Addendum No. 5

Project: Salem Community Schools
2021 FEMA Safe Room Additions

Project No.: 202020.01/02

Date: May 3, 2021

Partial Revised Site Grading Plan

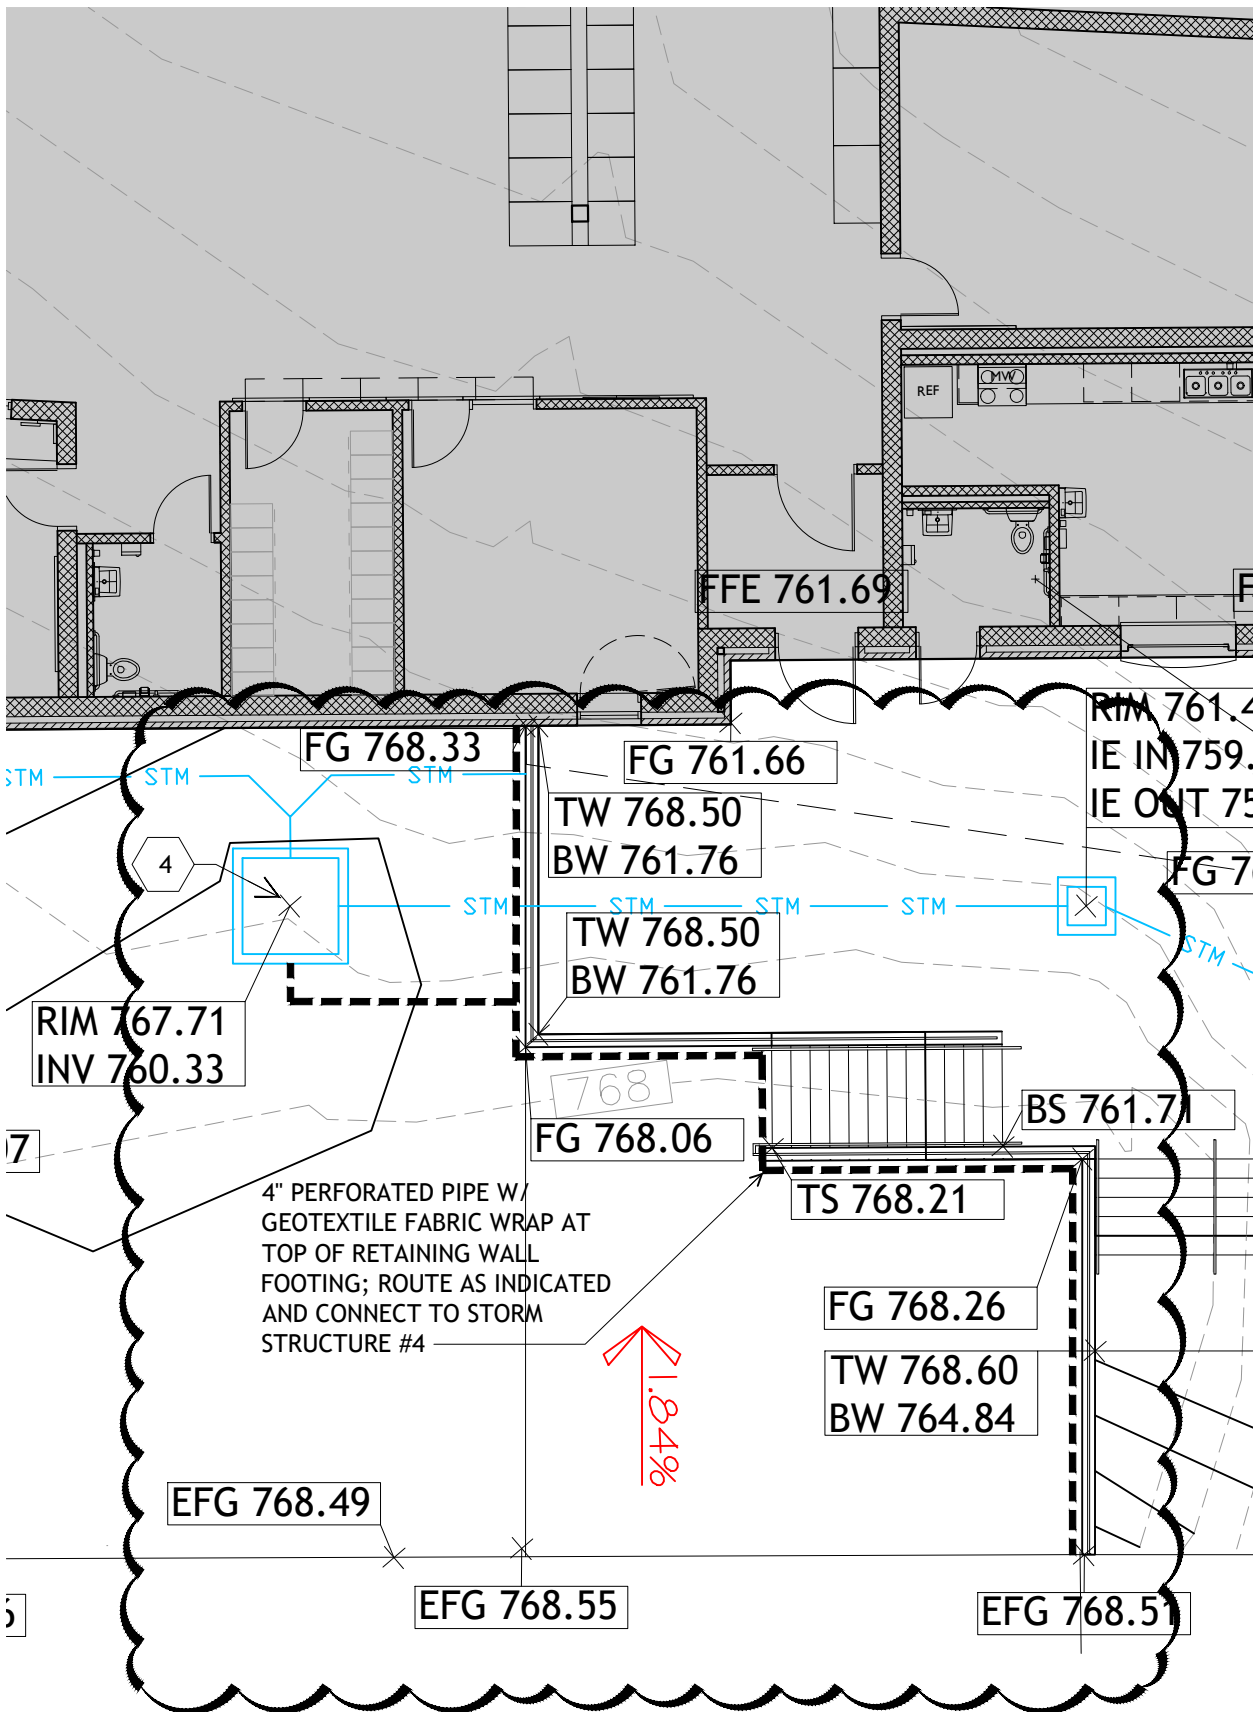
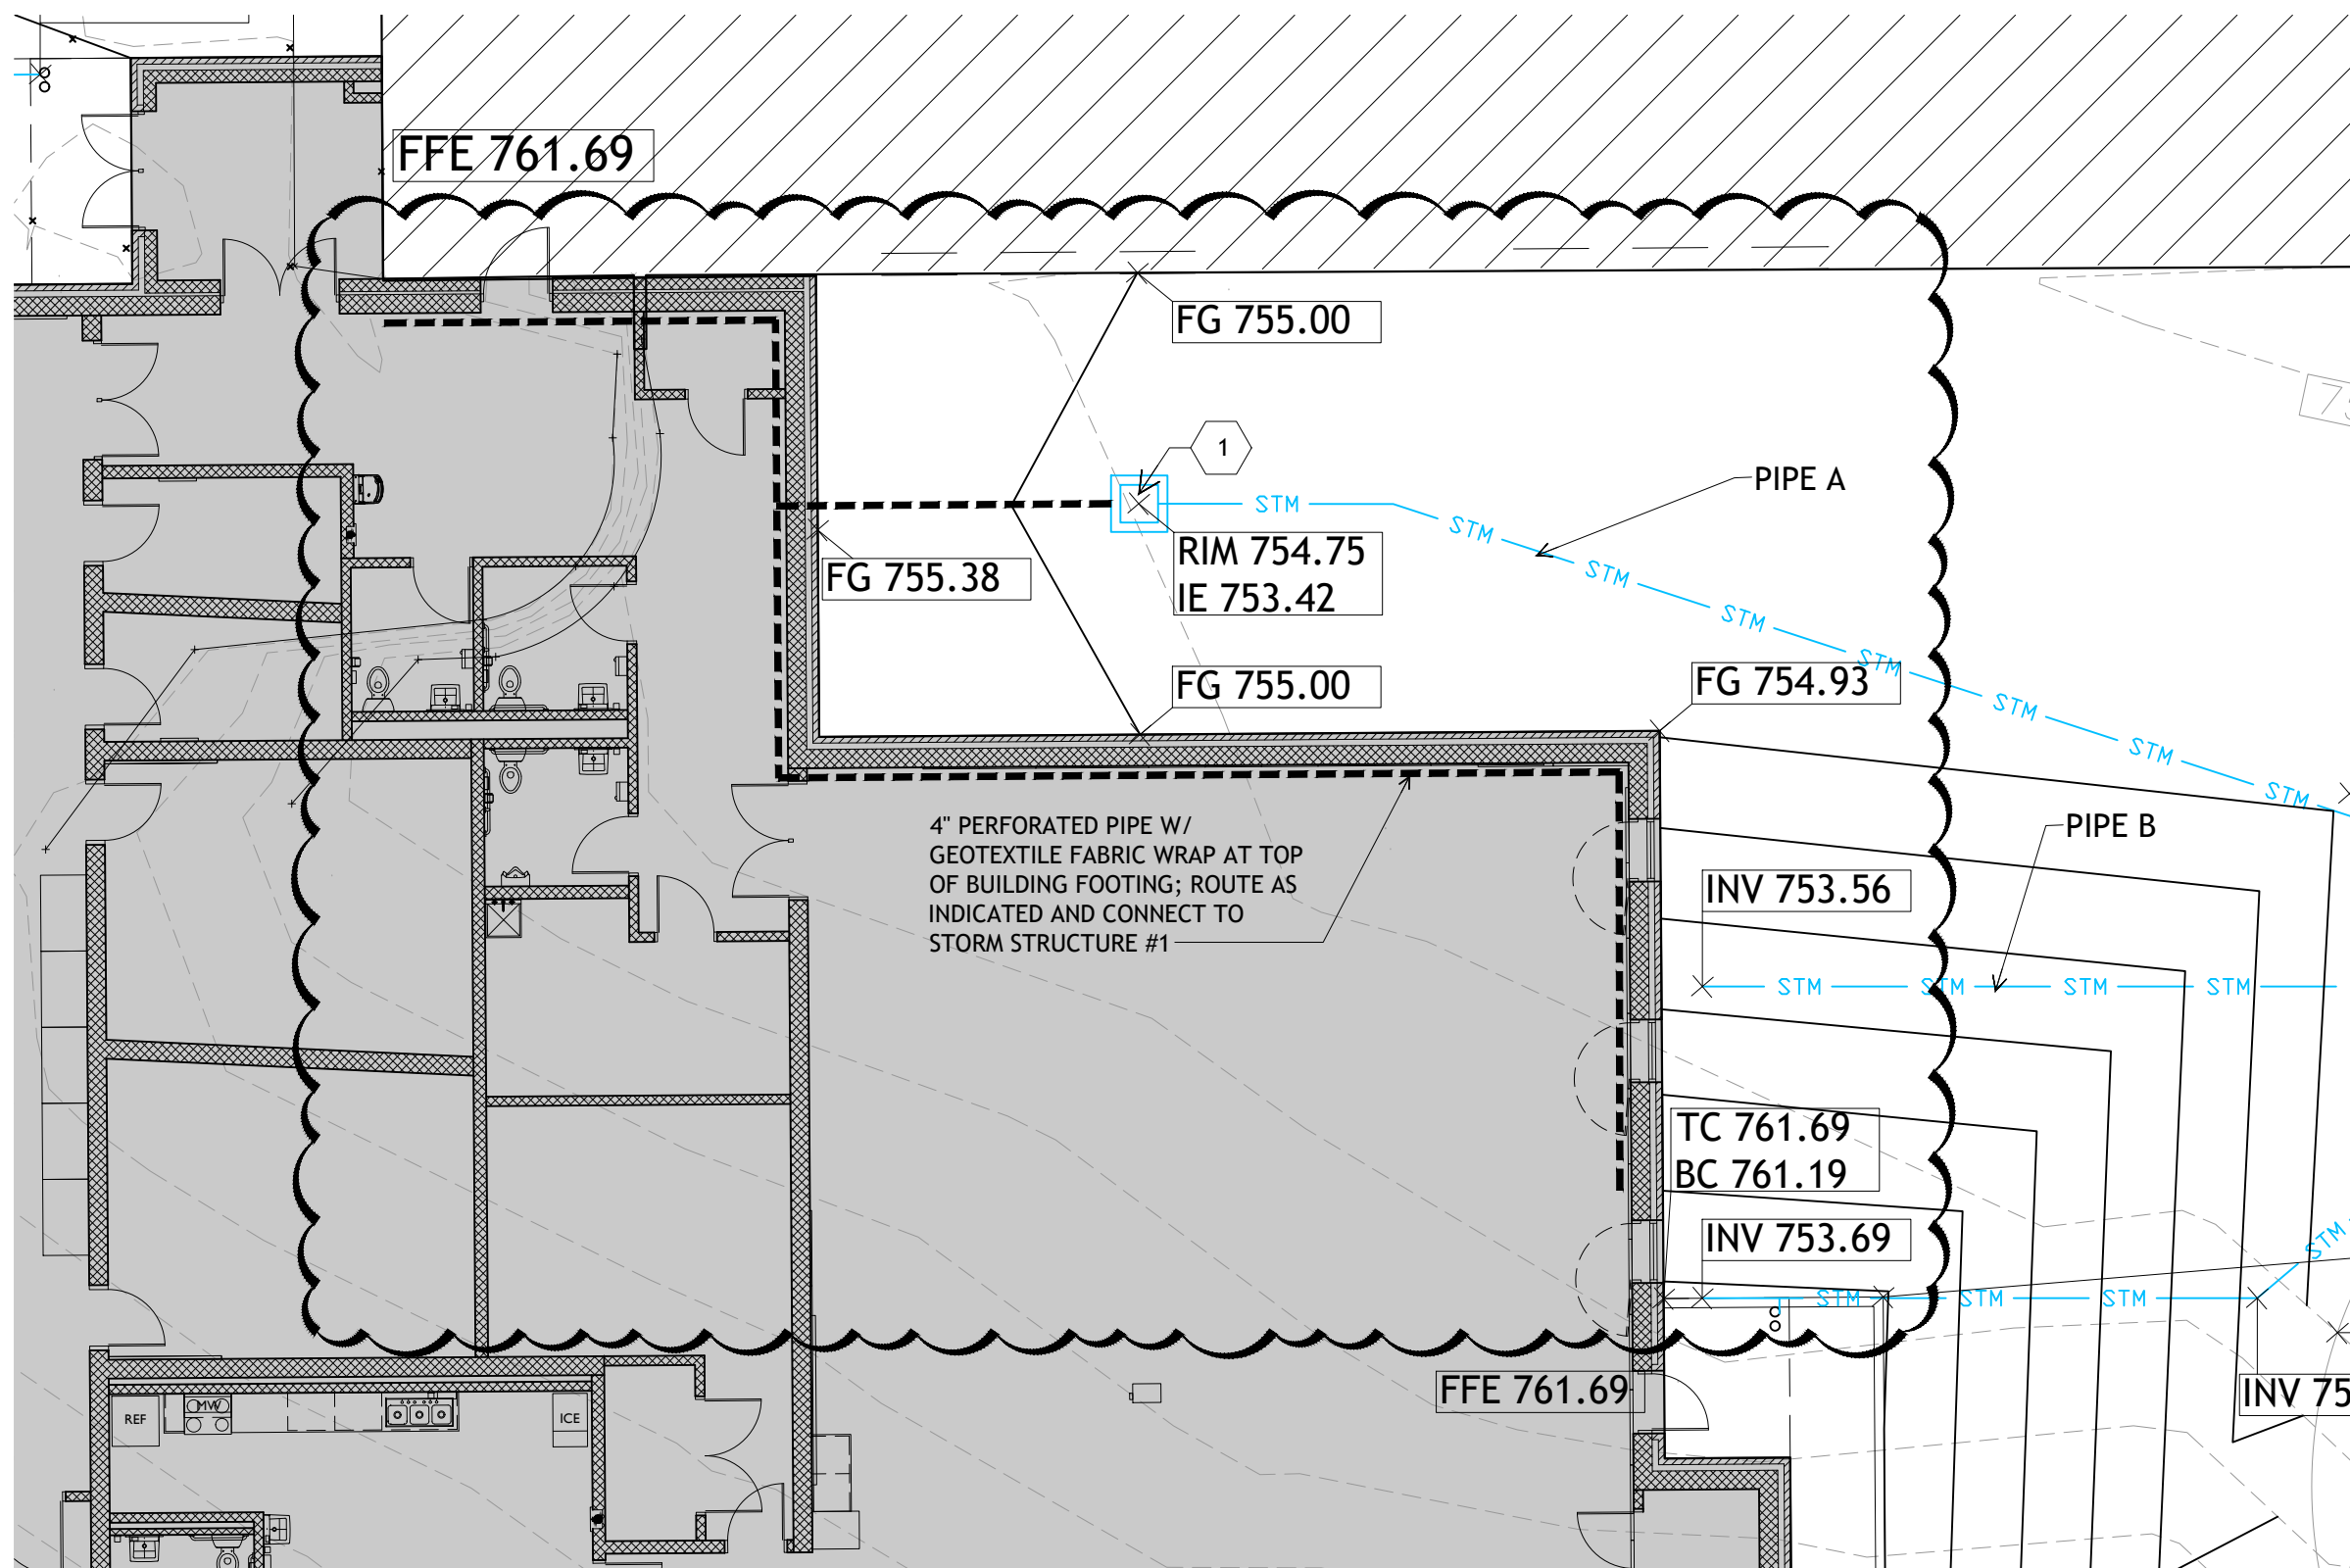
7. Drawing C201 -
Refer to attached Drawing AD-5f for perforated drainage piping (indicated as bold, dashed line) added at site retaining walls.
Refer to attached Drawing AD-5g for perforated drainage piping (indicated as bold, dashed line) added at building foundations in northeast corner.
Provide a concrete head wall per Detail 1/AD-5i at outlet of Pipe D and outlet of Pipe E.

AD-5h

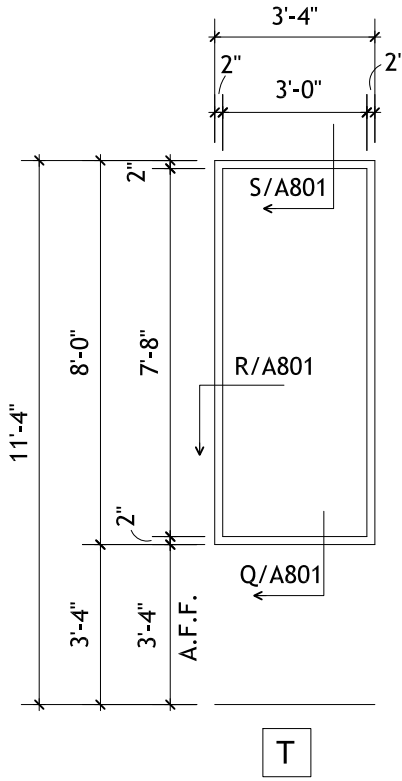
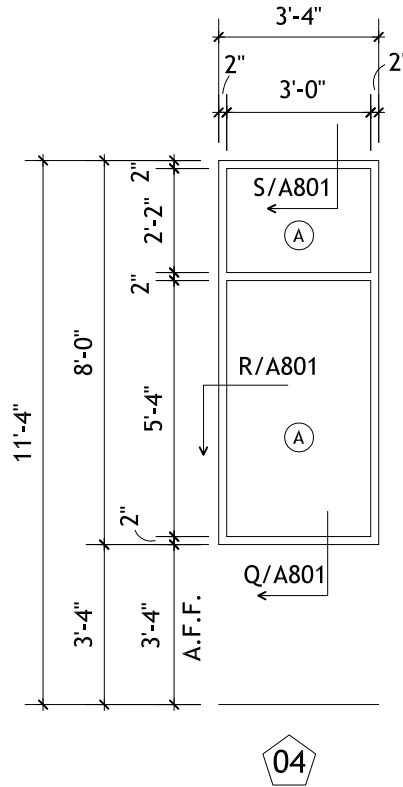
22. Drawing A801: As a general clarification, door elevations 2 & 3 are not used.
Remove the lite from door elevation 4.
Hollow Metal Frame elevation T: Revise per AD-5h.
Aluminum Storefront Frame elevation 04: Revise per AD-5h.
Tornado Shutter Schedule: Replace 8'-8" door height with 7'-8".
Door Schedule: Door B111: Add note "R2".
Detail U/A801: 8" CMU will not be touching 12" CMU as shown but will have a space at the jamb (similar to space at head shown on V/A801. Provide and install 16 gauge steel closure trim to cover gaps on both sides of jamb. Paint steel closure trim to match adjacent wall. See AD-3e (16/A801 Volume 1) for similar detail.
Detail V/A801: Provide and install 16 gauge steel closure trim to cover gap at head between 8" and 12" CMU. Paint steel closure trim to match adjacent wall. See AD-3e (15/A801 Volume 1) for similar detail.

25. Drawing I302: Detail 1/I302: Tall windows are shorter than original design. See AD-5h. Provide and install acoustic wall panel above revised window opening to match the top of adjacent acoustic wall panel.

Headwall Detail

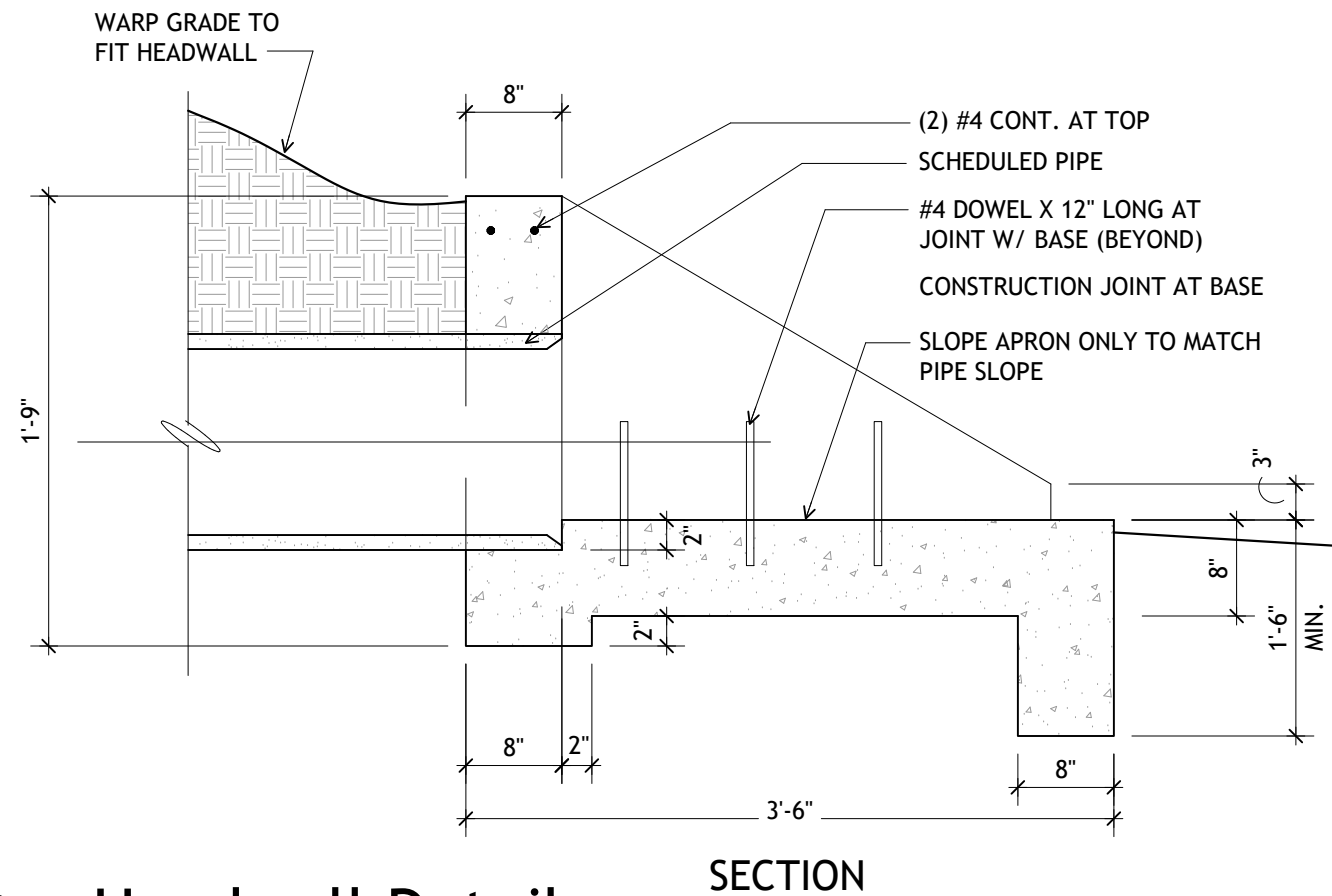
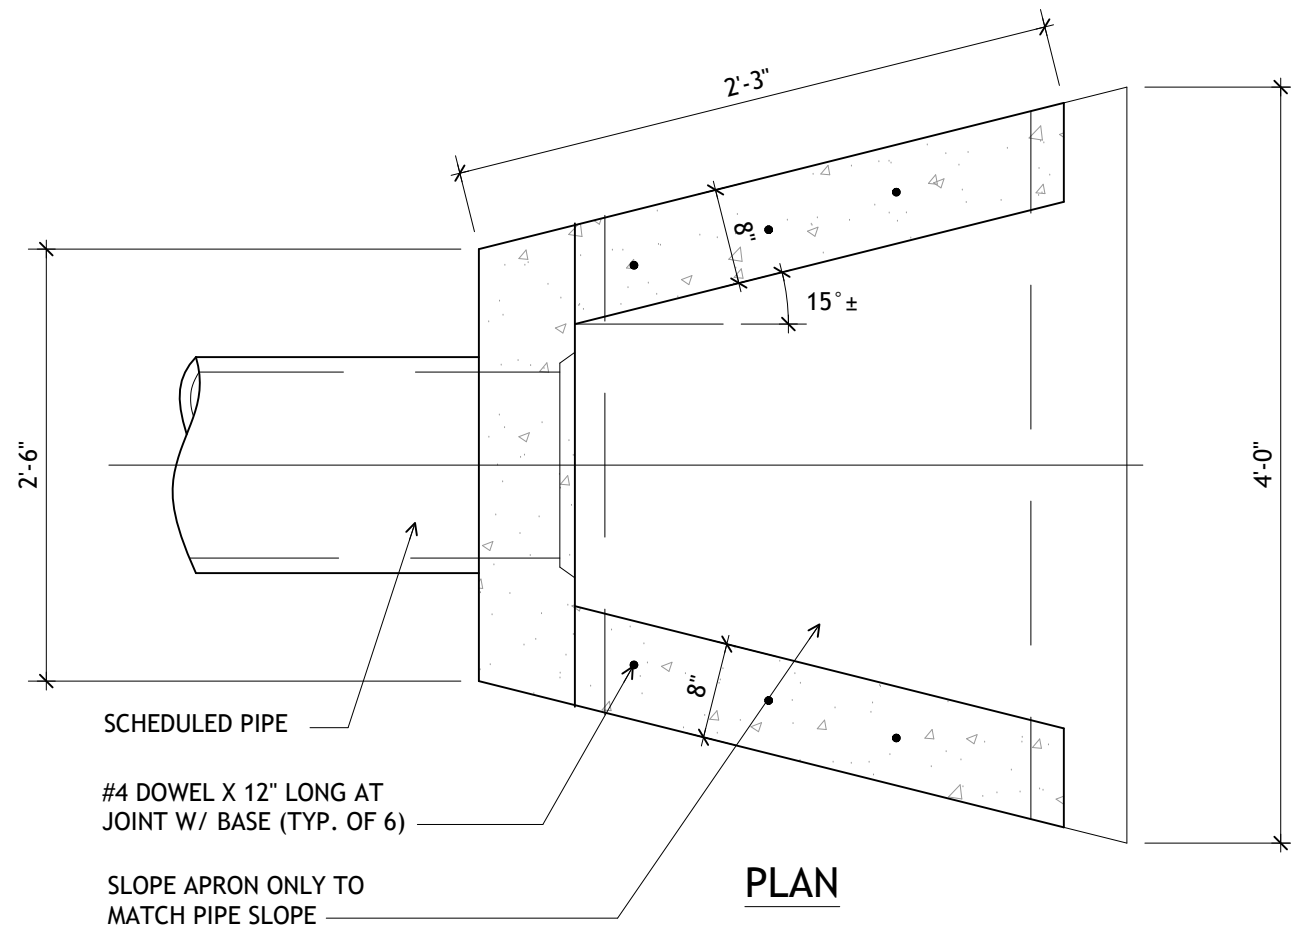
8. Refer to attached Drawing AD-5i for concrete head wall detail.
9. All Floor Plan Drawings - Concessions 121: Add a hand wash sink and replace the 2-bowl sink with a 3-bowl sink as shown on attached Drawing AD-5e. Refer to STW addendum items for additional information.

HEADWALL SHALL MEET OR EXCEED THE INDIANA DEPARTMENT OF HIGHWAYS APPLICABLE STANDARD DETAIL OF SLOPED AND FLARED HEADWALLS FOR PIPE.

REINFORCING STEEL TO BE MIN. GRADE 60, EVENLY SPACED.

DIMENSIONS AND QUANTITIES ARE APPROXIMATE, BASED UPON CONCRETE PIPE. ADJUST AS REQUIRED.

SCS
Sheet
PI01A

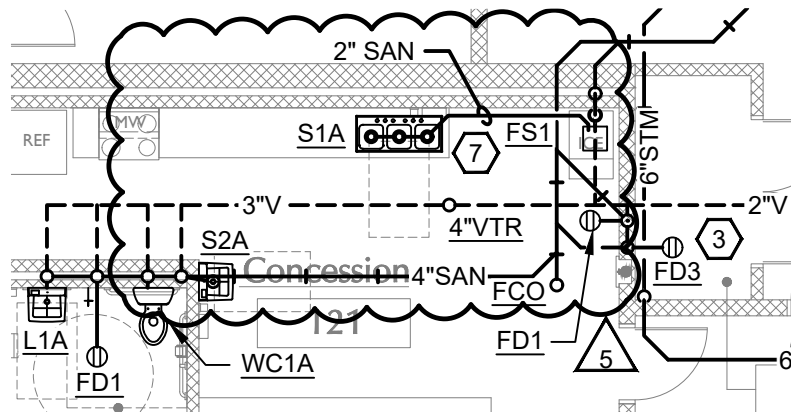
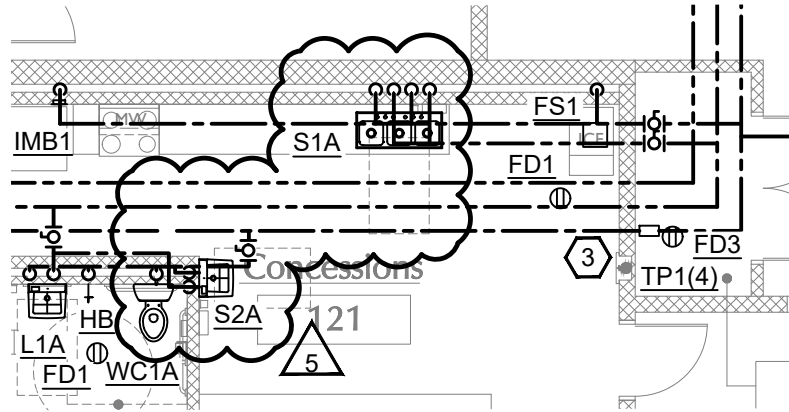
Item 1: Refer to attached Volume 1 revision sketches P101A, P201A, P502A, and P601A

- A. Sink S1A in CONCESSION 121 shall be changed to be a 3-compartment, casework mounted sink as indicated in revised PLUMBING FIXTURE SCHEDULE.
 - a. Sink S1A drain shall be 2" and discharge to floor sink FS1. Route drain line tight to plan North wall, coordinate routing with ice maker and beverage cooler. Slope at 1/4"/foot.
 - b. Coordinate sink installation with casework, refer to architectural plans.
 - c. Provide (2) cold and hot water lines to sink (additional S1A faucet has been added).
- B. Sink S2A has been added.
 - a. Sink S2A shall be wall mounted with the rim at 34". Provide with factory wall mounting bracket per revised PLUMBING FIXTURE SCHEDULE
- C. Floor Drain FD1 has been added in RR113.

7. HOLD 2" SANITARY DRAIN FROM SINK S1A TIGHT TO WALL BEHIND BEVERAGE COOLER. DISCHARGE TO FLOOR SINK FS1 WITH AIR GAP.
